Item 6.**Development Application: 136 Hay Street, Haymarket - D/2023/887**

File No.: D/2023/887

Summary**Date of Submission:** 29 September 2023**Applicant:** Terri Slater**Architect/Designer:** BVN**Developer:** The Trustee for Platinum Unit Trust**Owner:** Platinum Hotel Holding Pty Ltd**Planning Consultant:** Architectus**Cost of Works:** \$104,334,709.00**Zoning:** SP5 - Metropolitan Centre**Proposal Summary:** Approval is sought for the construction of a 16 storey mixed use building over 4 basement levels, comprising retail uses, tourist and visitor accommodation, and a supermarket.

Figure 31: Approved Stage 1 building envelope - D/2015/1490/A

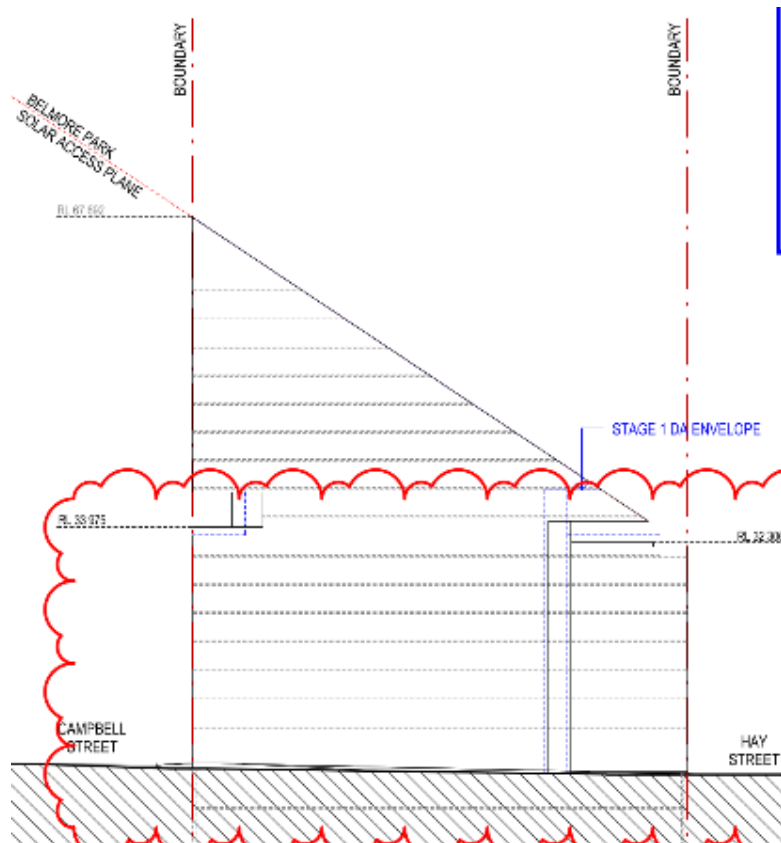
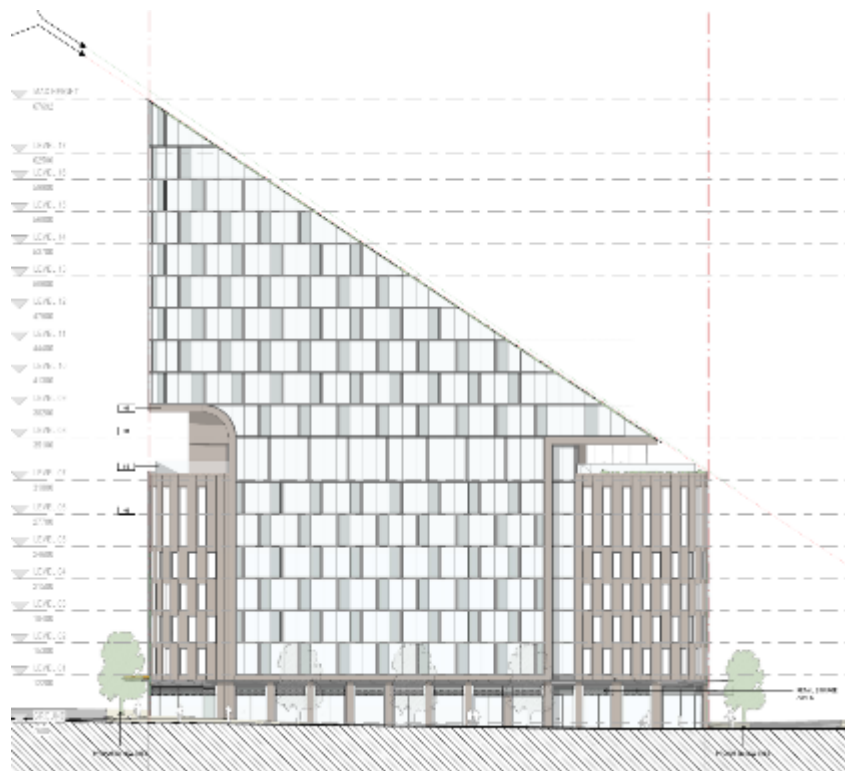
57. In addition to complying with the conditions of the Stage 1 consent, the City's modelling team has confirmed that the submitted 3D digital model is generally consistent with the approved building envelope, with the exception of minor facade elements (awnings, architectural detailing), and the glass enclosed portion of the level 7 terrace.

Figure 33: Proposed unenclosed nominated bulky waste area for the supermarket

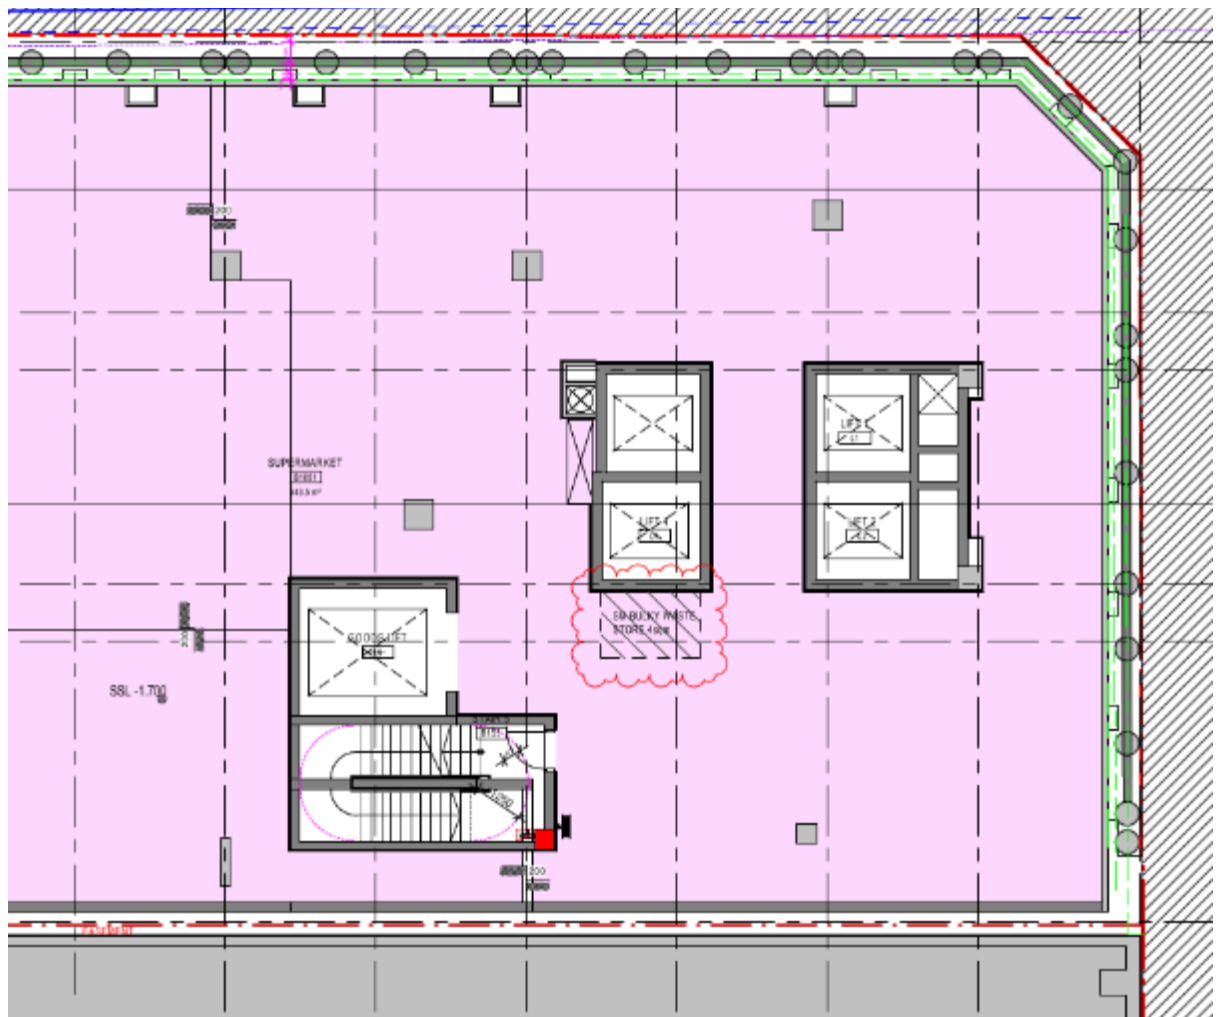
86. Amended architectural plans were subsequently submitted which depict waste storage areas and bins on the plans, as well as an amended waste management plan, to provide additional justification for the proposal not meeting the requirements of Council's current waste management policy. It is noted that information was not provided directly from Coles to confirm the standard waste management practices of Coles supermarkets.

87. The waste generation estimates in the amended waste management plan have been revised to closer align with the City's recommendations and estimates. A greater frequency of waste collection is proposed to accommodate the shortfall in waste bins and storage areas. While the City's Waste & Cleansing team generally accept the revised spatial allocation of waste storage areas and collection frequency, the unenclosed nominated bulky waste storage area for the supermarket (4 sqm) on basement level 1 (shown below) is not considered sufficient. Council's Waste Management Officer recommends that an enclosed (or caged) area be provided for the supermarket bulky waste that is large enough to store two days generation of waste.

88. In addition, Council's Waste Management Officer also note that the hotel and retail waste storage area on Basement Level 2 (39 sqm and 22 sqm) have engaged the use of a cardboard baler to reduce the waste storage space needed, and concern is raised regarding the practicality of transporting the baled cardboard to Ground Floor Level for collection given that a forklift is generally required to transport baled cardboard.

Figure 34: Proposed ground floor plan showing the path of travel in red for the waste bins to reach the goods lift from the retail tenancies

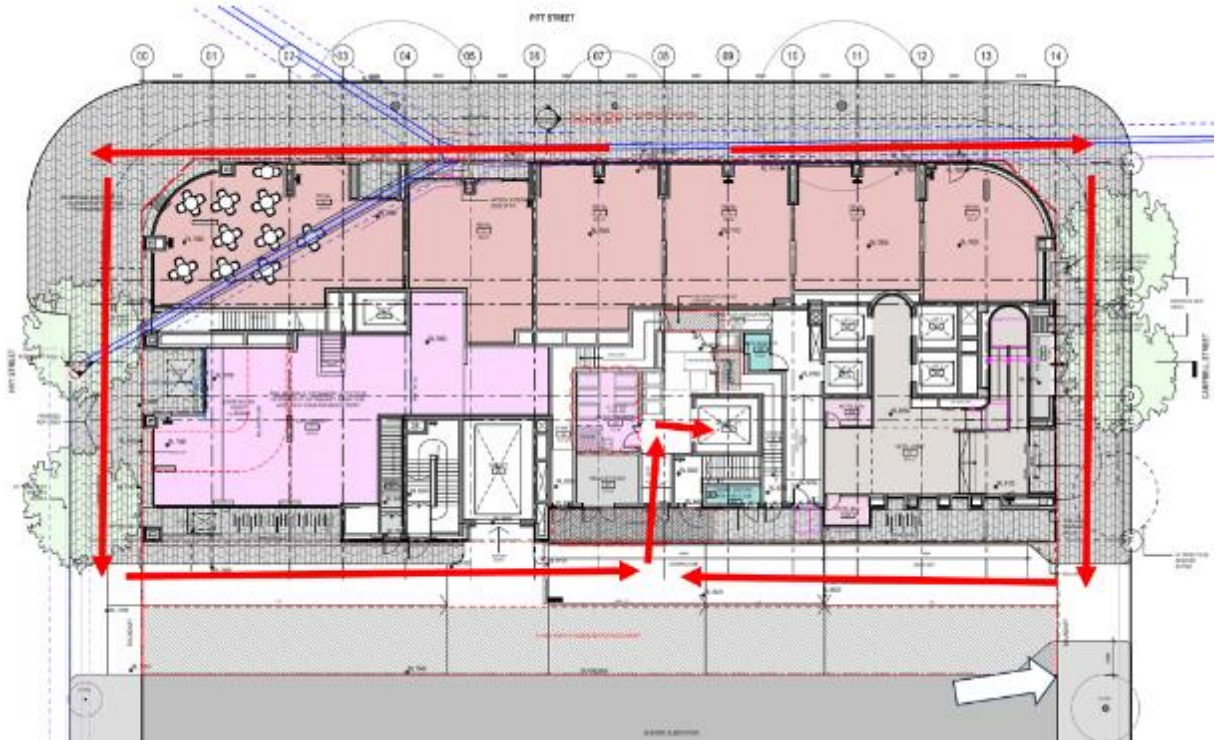
89. The applicant justification for the waste arrangements for the retail tenancies is that it was previously approved under D/2017/727, this arrangement is common in other developments within the City, and that providing a BOH (back of house) corridor for the retail tenancies would result in a significant reduction in the floor area of the retail tenancies, such that they would become unviable.

90. The proposed waste arrangement for the retail tenancies is not supported by Council's Waste & Cleansing team, noting that bins for the retail tenancies will need to be transported between 70-100m around the outside of the building to reach the waste storage area and goods lift, as demonstrated in the below figure.

91. The ground floor plan indicates that providing BOH access to the retail tenancies could potentially be achieved with minimal reconfiguration of the ground floor layout by providing internal openings at the rear of the two middle retail tenancies, and extending the proposed service corridor to access the remaining retail tenancies as demonstrated in the below figure.

Figure 36: Podium datum (north elevation) in relation to surrounding development along Hay Street

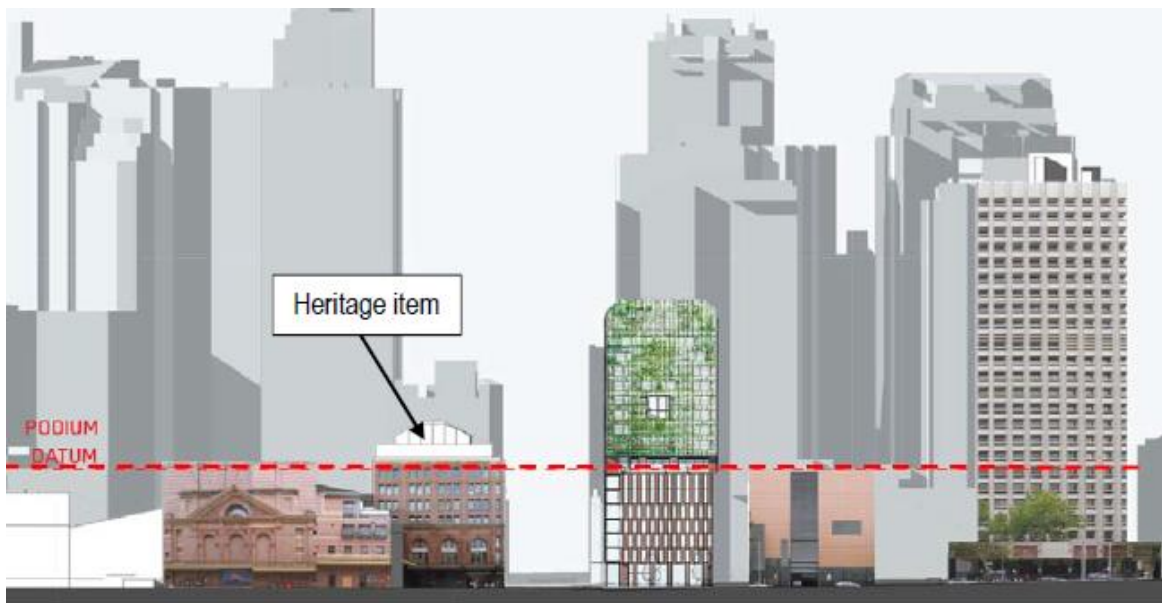
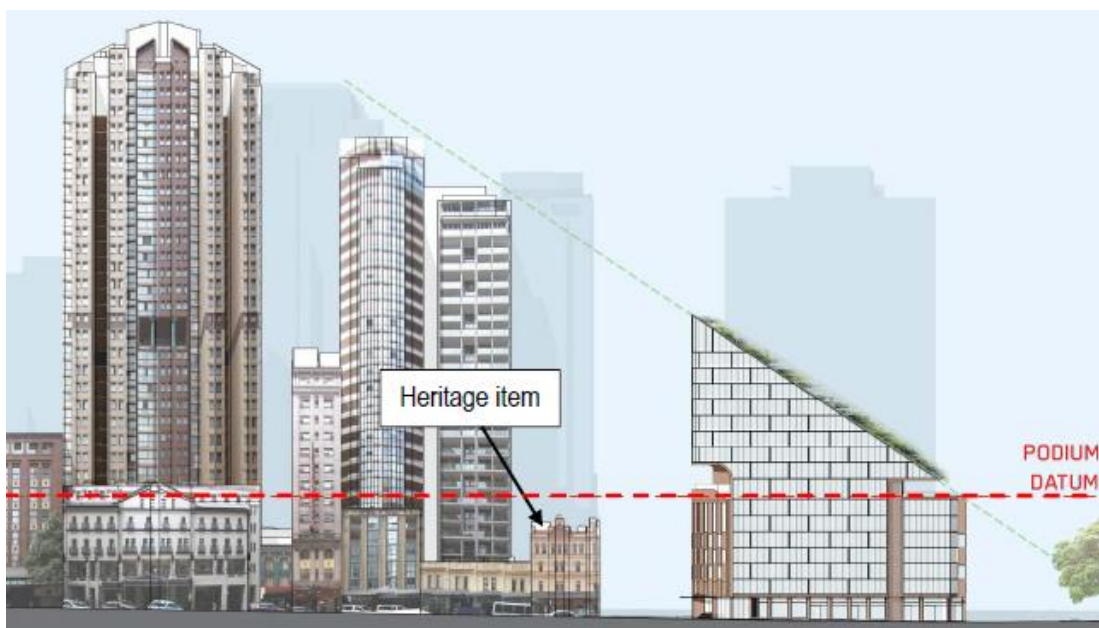
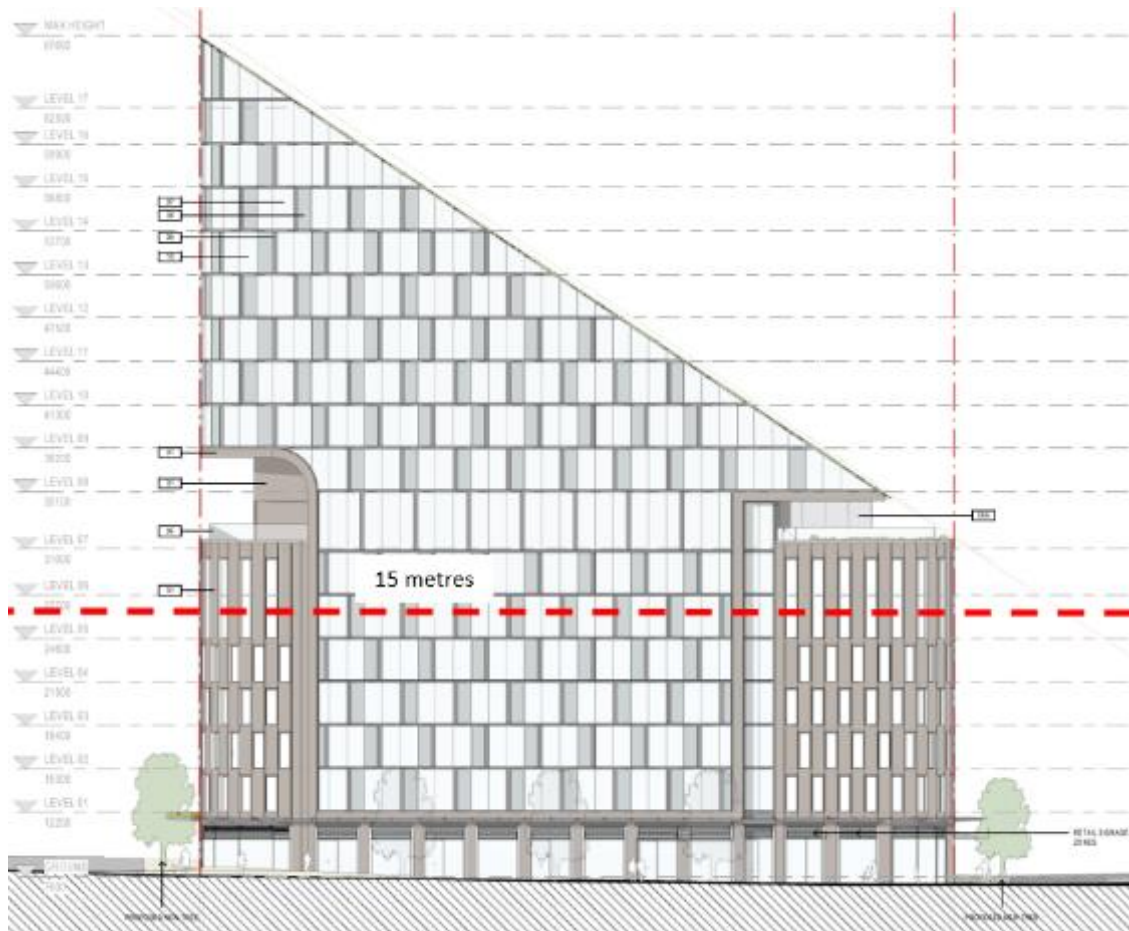
93. Section 5.1.1 of SDCP 2012 requires a street frontage height for new buildings located within the Railway Square/ Central Station Special Character Area of no greater than 15 metres above ground level. The minimum setback required above the 15 metres street frontage height is 8 metres to Hay St, Campbell St and Pitt St.
94. The proposed development provides a street wall height that gradually increases from 21 metres at the southern end of the site to 60 metres at the northern end. The only setbacks occur at Level 7, comprising outdoor terraces with external walls/ glass line setback approximately 4 metres from the northern boundary and 6 metres from the southern boundary.

95. The non-compliance with the street frontage height and setback requirements under DCP 2012 are considered acceptable as the scale of the building has been minimised through massing and material treatment. In addition to the tapered height, the building is articulated as a masonry base intersected by a glazed volume, with a vertical slot extending from the ground floor to Level 8 at the southern end of the western façade (Pitt Street), and horizontal insets at Level 7. As such the massing is modulated in a way that minimises the building’s bulk by breaking it up into discreet components.
96. The masonry base is consistent with and complements the street frontage heights of surrounding heritage items and is proportionately consistent with the brickwork to window opening ratio, of the Manning Building at 451 Pitt Street. Refer to below figures.

Figure 39: Level 7 southern terrace with recommended setback of glass line in red

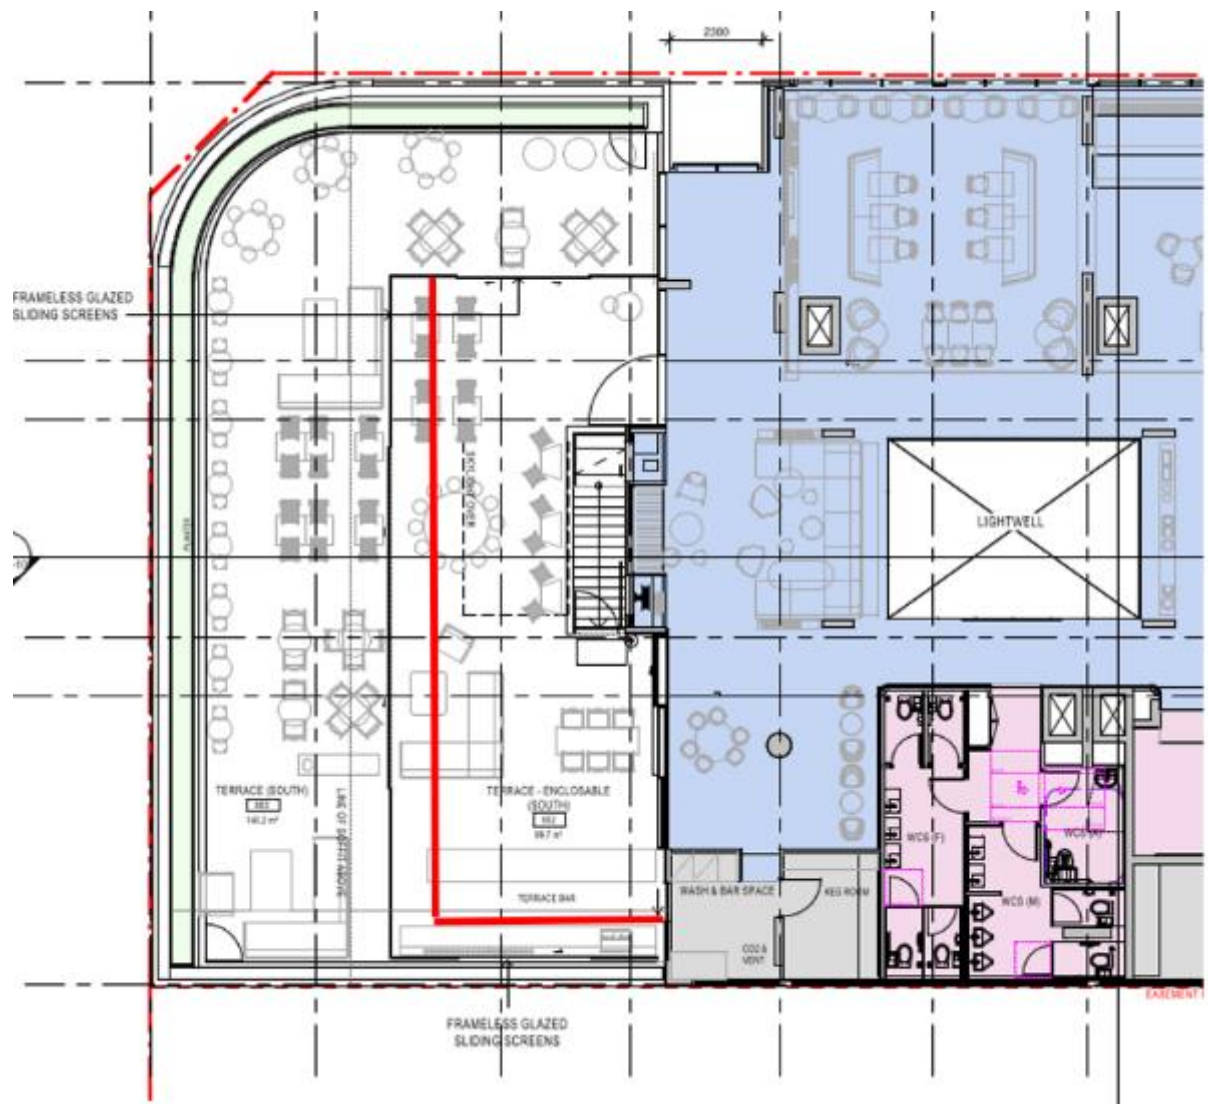
97. As discussed elsewhere in this report, the proposed detailed design is consistent with the approved Stage 1 Concept building envelope, and additionally the form of the proposal is constrained by the various easements and covenants on the subject site, as well as the Belmore Park Sun Access plane. Therefore, the non-compliance with the DCP street frontage height and setback controls is considered acceptable within the context of the subject site.
98. An increased setback of 1m of the glazing line of the level 7 (podium level) southern enclosed terrace from the southern and eastern boundaries is recommended to reduce the bulk which diminishes the reading of the articulated rebate, as shown in the below figure.

99. A condition of consent is recommended to increase the southern and eastern setbacks to the glass line of the level 7 southern enclosed terrace.
